Interactive comment on “Applying SWAT to predict orthophosphate loads and trophic status in four reservoirs in the upper Olifants catchment, South Africa” by J. M. Dabrowski

Author Response to Reviewer 1:

Fig. 1. Revised version of figure 4

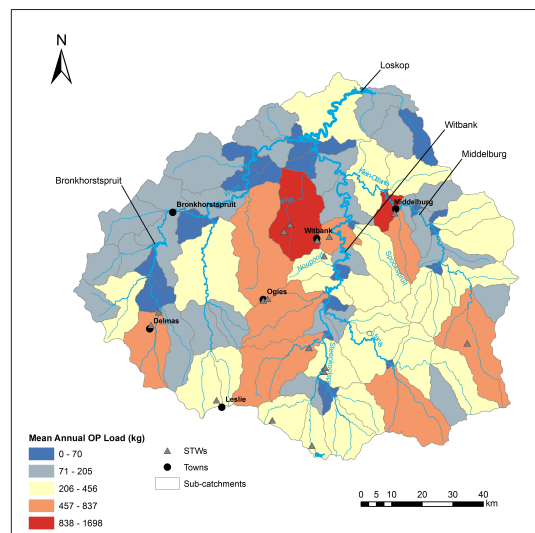
Page 1346, Line 28: The map has been revised to indicate mean annual OP loads generated per sub-catchment (as opposed to accumulated loads from upstream to downstream). This has the effect of clearly identifying which sub-catchments are responsible for generating high OP loads.

Figure 4: The actual figure and the figure caption have been updated as per the reviewers comments.
